Submission Ulan West Continued Operations Project - Modification 8 – Impact on mining on groundwater and catchment.

This is an objection to UWCO Mod 8 project.

Dr Julia Mullins Imrie BSc. Grad Dip Water Res.

Figure 1 - AGE (2025) – App.D Calibration and Uncertainty Hydrographs

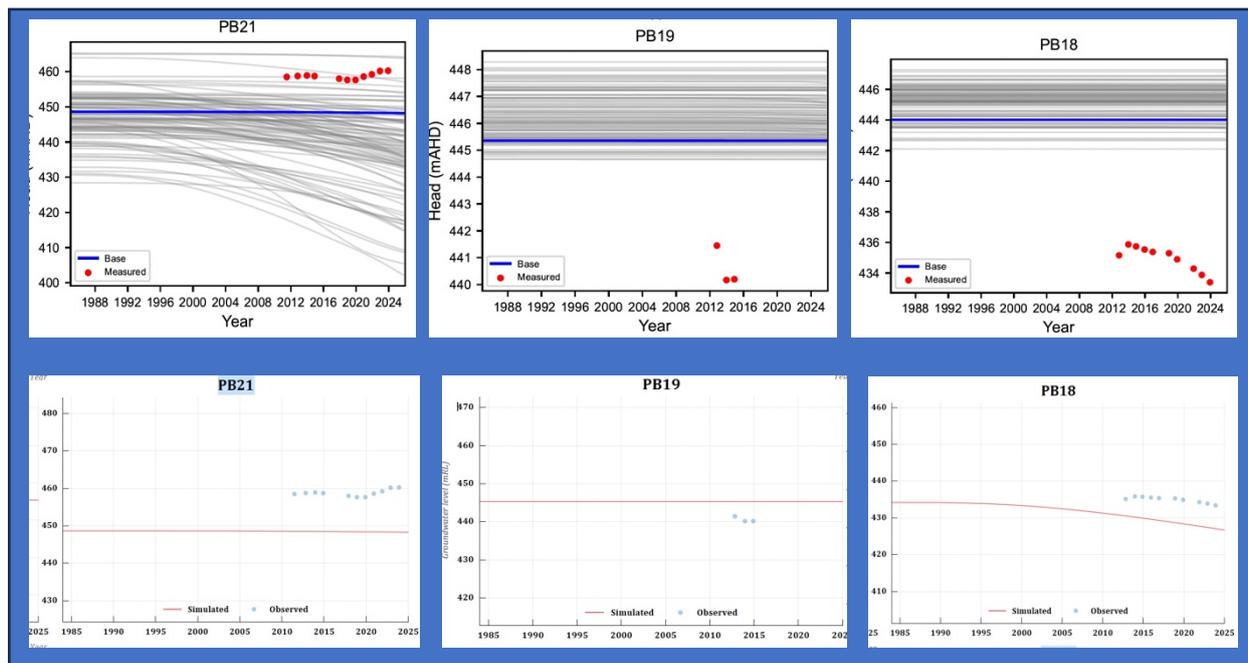
There are also a range of private bores where data collection is infrequent and inadequate, the model either underestimating or overestimating water levels by 5-10 metres (see PB18, PB19, PB21, Fig: 1 below).

Figure 2 - AGE (2025) – App.D Calibration and Uncertainty Hydrographs

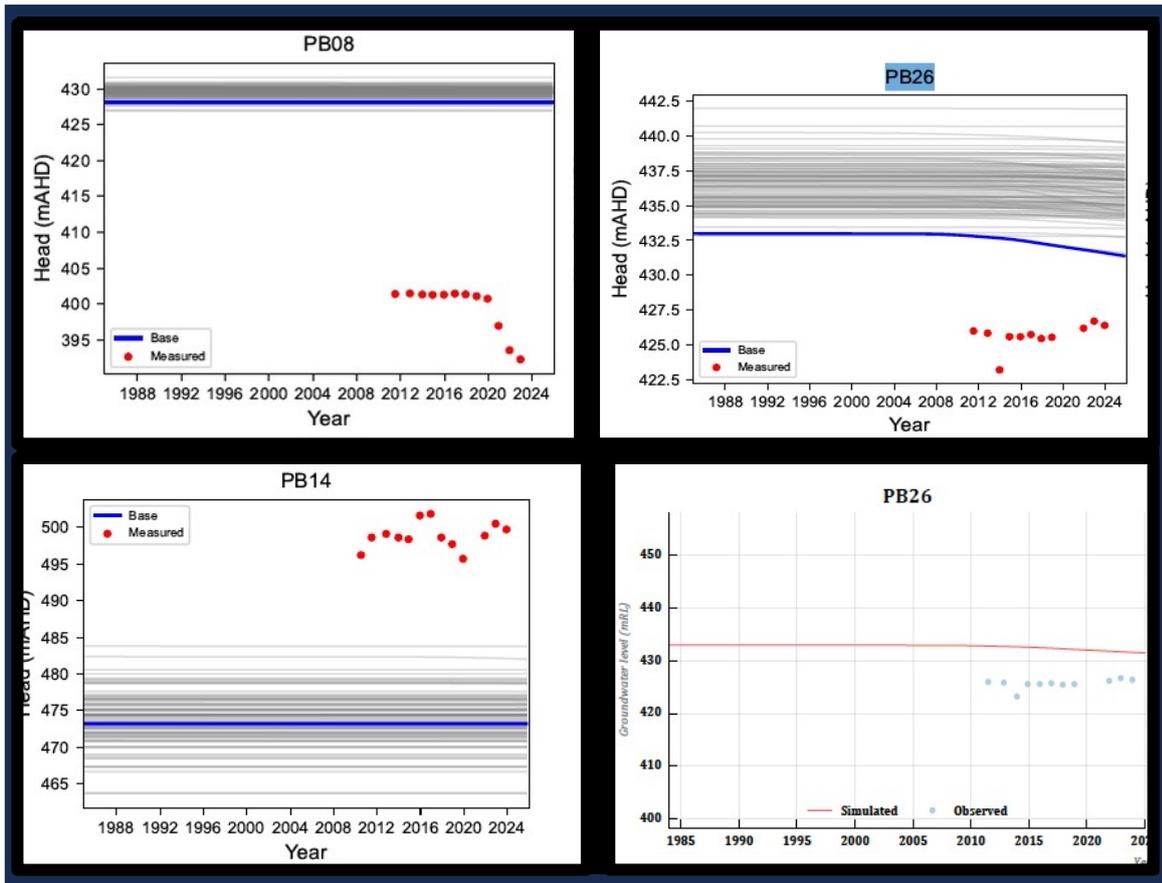
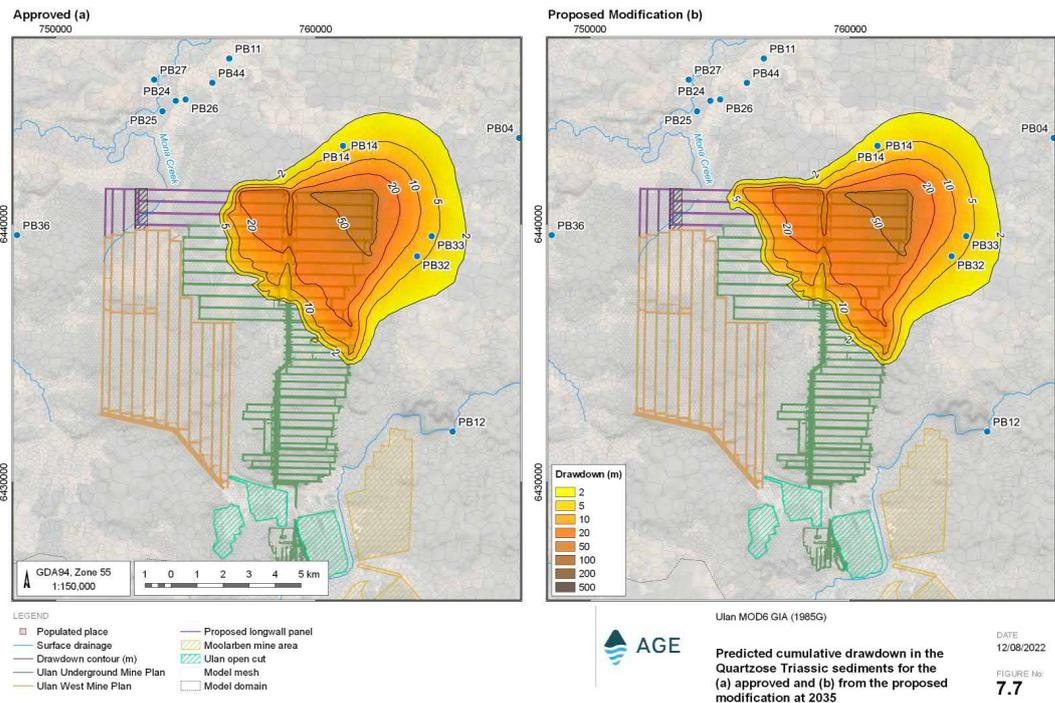
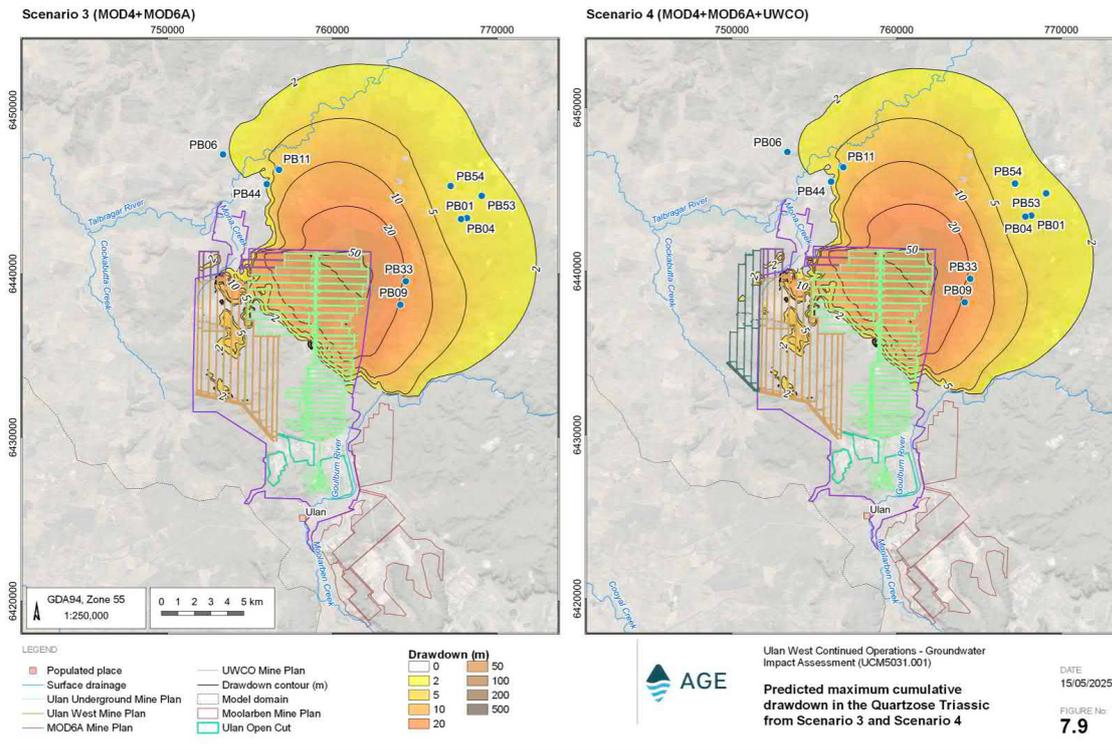
North of the longwalls, near the Talbragar River (regarded as ‘highly productive alluvium’) and the permanent flowing Curryall Creek (in the north-east above UUG), the measured ‘observed’ groundwater levels in private bores PB08 & PB14 (screened into the Triassic and Jurassic strata) differ significantly from the model ‘simulated’ levels by over 20m, while PB26 (Triassic) differ significantly by over 7 metres (Fig. 2.) The recent AGE AOM(2024) modelling predicting mine induced drawdown of PBs near the Talbragar by over 6 metres, and PBs near Bobadeen Creek, east of the mine by 18-32 metres (Table 7.4 AGE).

The inadequacy/inability of the model to replicate observed groundwater levels in these areas significantly diminishes the confidence in the model to predict reality. Model predictions of reduced impacts with groundwater ‘recovery’ and ‘mounding’ *increasing* baseflows in the years 2061-2181, are purely speculative and do not account for potential ongoing leakage through the fractured coal seam.

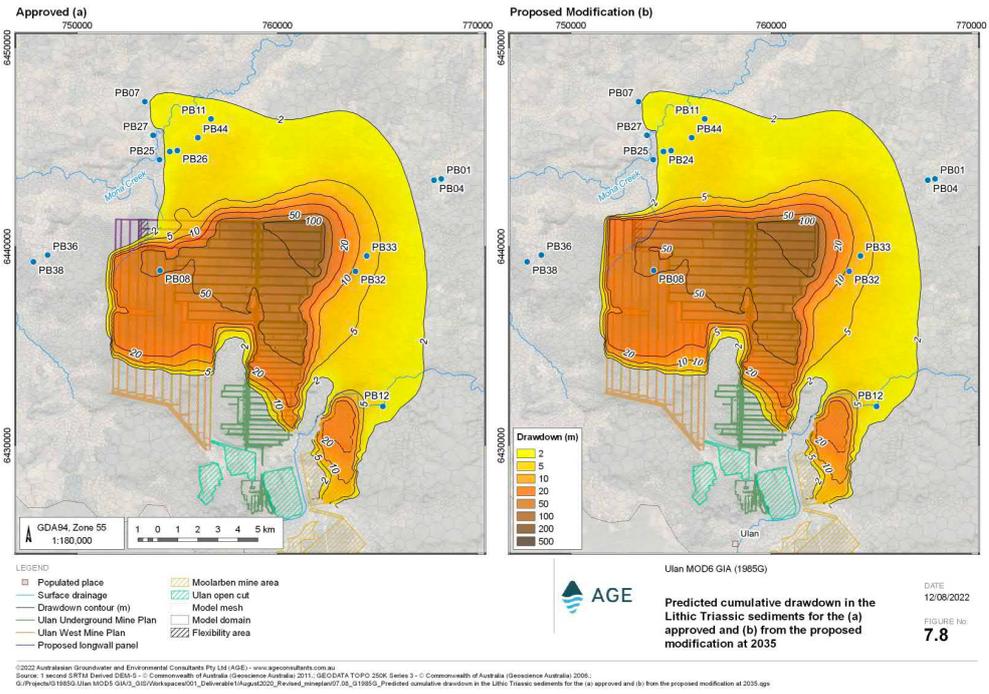
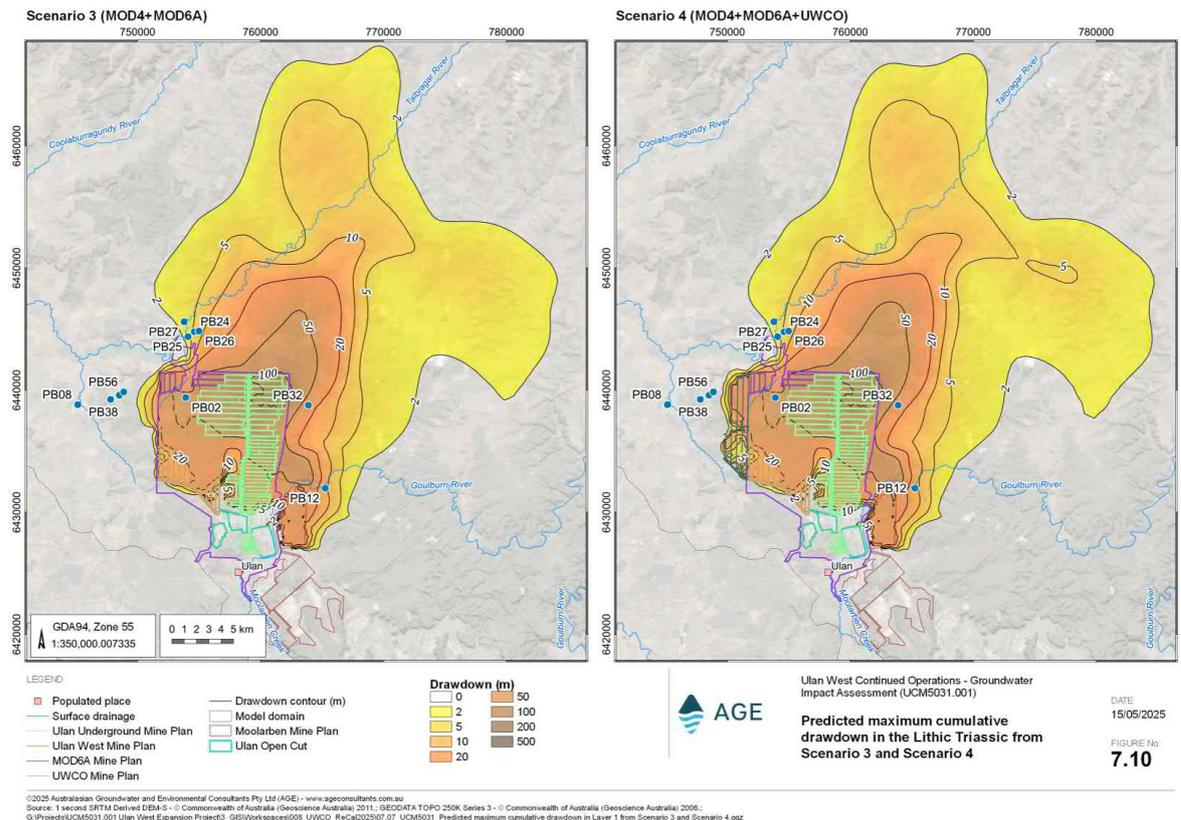
It is important to note that the AGE MOD 6 2022 model (see 7.7 below) **did not initially show mine drawdown of the Triassic groundwater extending as far out as the Talbragar** - affecting private bores PB11, PB24, PB25, PB26, PB44. While a rejigged model of AGE MOD 6 version (for the UWCO proposal) does show the Talbragar being affected by mining drawdown (see 7.9 further below).

The updated model AOM(2024) shows a significant increase in mine drawdown extending mining impacts to over the Talbragar River in the north, over Curryall creek in the north-east and down to the Goulburn River at The Drip gorge in the south. The proposed mining has the potential to adversely impact the Talbragar River, Curryall Creek, Bobadeen Creek and the Goulburn River catchment and alluvial aquifers. Such impacts have not been rigorously addressed or assessed in the UWCO Mod 8 proposal.

The MOD 6 AGE EIA (2022) version for the Triassic 'lithic layer' demonstrates the dramatic difference between the 'approved' 2022 version of MOD 6 (see 7.8 below) and the AOM(2024) MOD 6 version (see 7.10 further below). Mine groundwater drawdown is now well out to the north over a huge area of the Talbragar River alluvium. South-east of the mine, Triassic groundwater is predicted to decline 50-100m beneath the Goulburn River and The Drip gorge. Such significant increases in the predicted mining drawdown of quality groundwater that provides drought-proofing baseflow to our creeks, rivers and private bores is unacceptable socially and environmentally.

Figure 3: PZ29 (north of The Drip)- AGE (2025) – App.D Calibration and Uncertainty Hydrographs

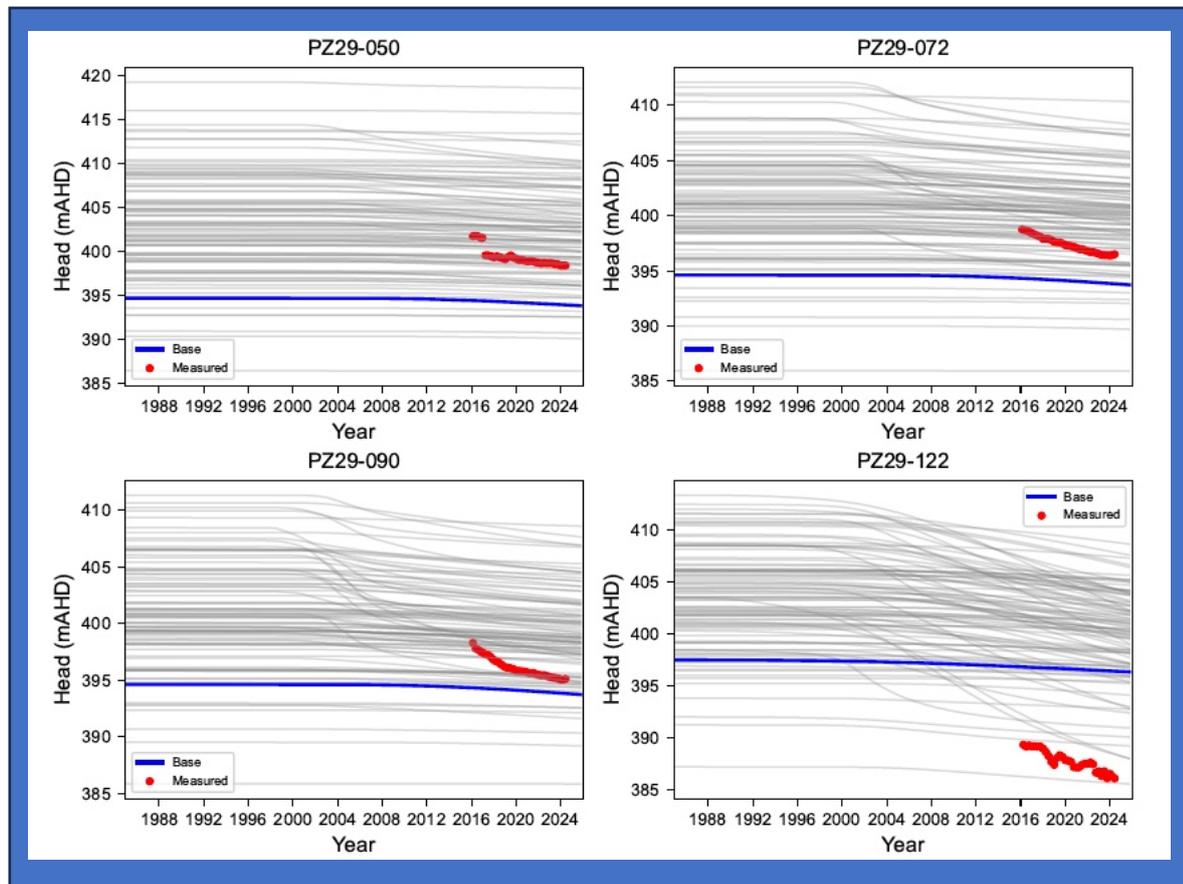
PZ29 (050,072,090, 122- vibrating wire VW) monitoring bore is located 1.2 kms north of The Drip and is the only monitoring piezometer measuring Triassic groundwater levels above The Drip and Goulburn River. Unfortunately, the groundwater hydrochemistry (major ions) of this bore has never been analysed by UCC precluding any comparison of water types with The Drip seep water. Aquifers in this area could potentially contribute the 'perennial' groundwater flow supporting The Drip GDE (the hydraulic gradient flow is towards the river.)

Figure A 2.5
Geological cross section through The Drip (see Figure A 2.1 for A - A' location)
Ulan Groundwater Model Recalibration (UCM5031.001)

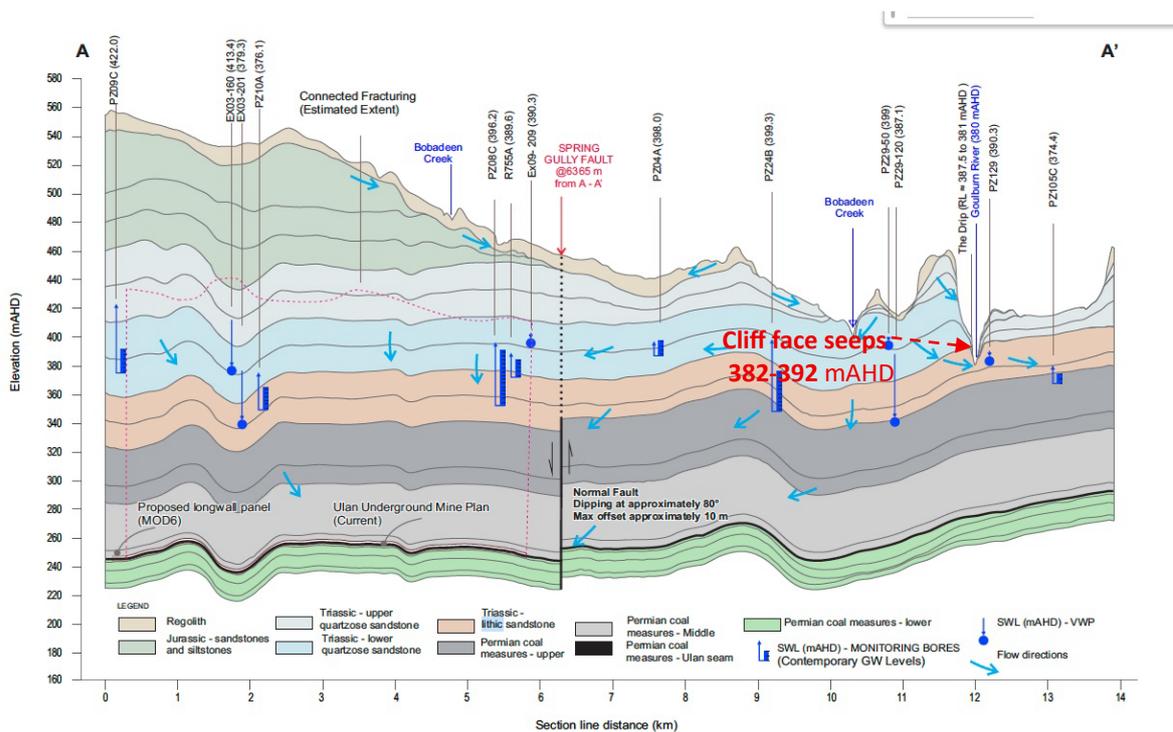
The conceptual Geological cross-section through The Drip (Figure A 2.5) misrepresents the height of groundwater discharge from The Drip face and skews the 'conceptual' hydraulic gradient. See the actual seep level of 382-392mAHD (inserted in red). Groundwater discharge may very likely be subjected to a > 2 metre drawdown over-time in and around The Drip water source and Goulburn River as groundwater gravitates towards the depressurised UCC and Moolarben Coal mine underground goafs. The UCC Consolidated Consent conditions 33 require that, "The Applicant **must ensure that the project has no impact on the water supply to the "Drip"**". How can this be proven or disproven considering the confusing modelling predictions and contradictory reporting?

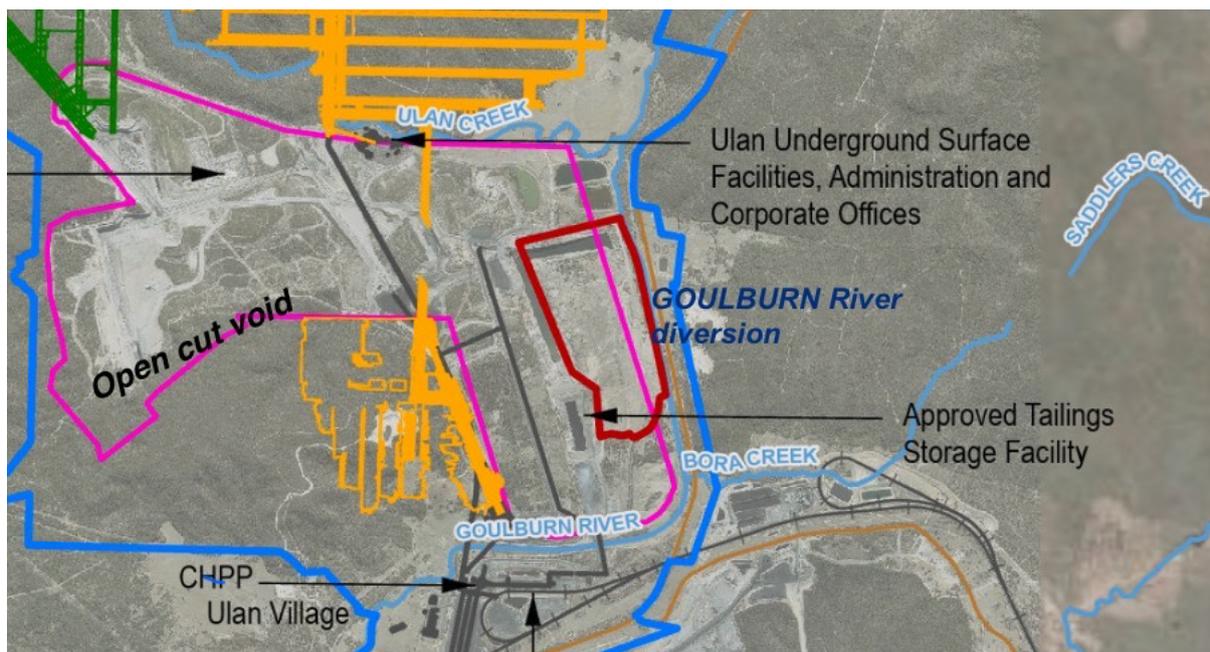
UWCO plan to dispose of tailings and RO waste from the current and expanded mine operations in a 132ha area abutting the Goulburn River where the diversion meets the original channel – and remnant alluvium (see Fig.4). This location is unacceptable risking groundwater contamination and seepage into the river system over time – either through the diversion OR the remnant river

During extreme or prolonged rainfall events, it is not practicable solution to manage overflow from this facility by ‘pumping’ from dams or lowering groundwater levels subject to ‘mounding’. Nor assume any seepage will report/drain to the east pit, which has potential connectivity to the groundwater system⁷ (and the river) when levels exceed 364- 385mAHD. There appears to be no detailed monitoring or assessment of the subsoil contained within the original Ulan Coal Open-cut (Pit 1) apart from a reference to an Aurecon report – not supplied. It appears the potential risk from stock-piled overburden and removal of established 6 -30 year-old native revegetation stabilising this fragile area, have not been considered in any detail.

- An alternate disposal site should be found, such as the open cut void in Ulan west infrastructure area
- UCMPL should be required to install groundwater monitoring bores between the current four tailings dams , the East Pit and the river (Fig.5) and report monthly on standing water levels and groundwater quality and risk of connectivity or leakage to the Goulburn River alluvium or river bed.
- Analysis of downstream river water quality is currently limited to only four parameters (pH, EC, Turbidity). Both mine water discharge and downstream surface flow should be fully analysed for a suite of hydrochemical parameters (metals and salts) and reported 4 times per month (random/weekly grabs)

Figure 5 - Google Maps aerial of the site, that shows the current active (4) tailings dam along the south arm of the East-pit infrastructure and open cut void that require monitoring

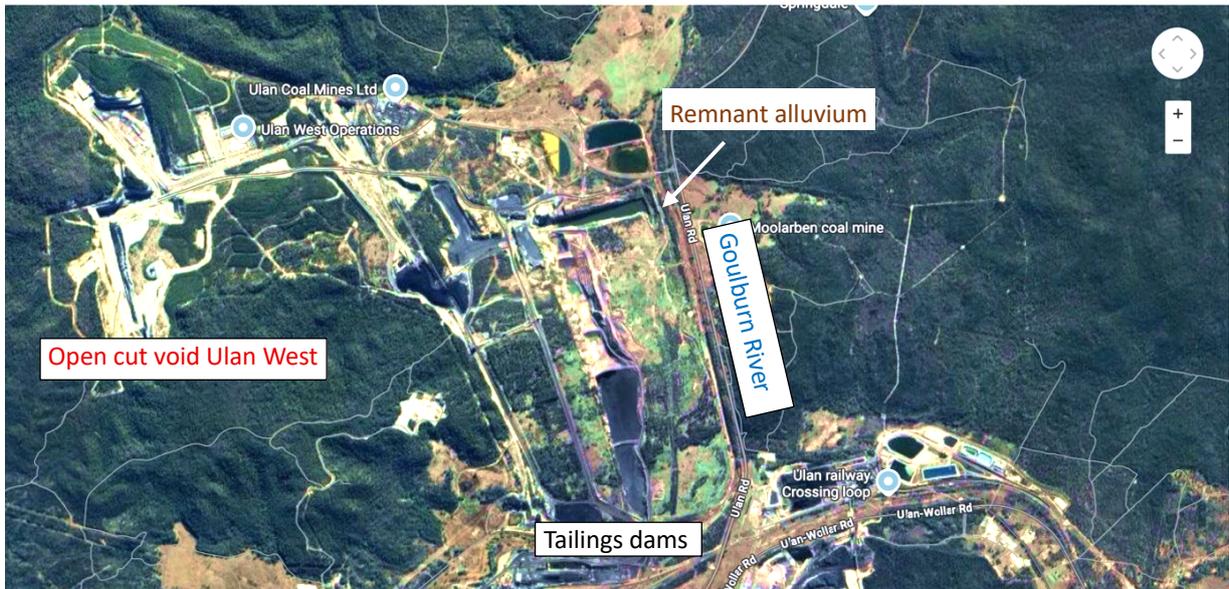
- *Absence of past and current monitoring and reporting of groundwater levels and water quality associated with the existing tailings dams (4) connected to the East Pit water storage, with potential connectivity through river alluvium with the Goulburn River should groundwater levels reach a critical height.*
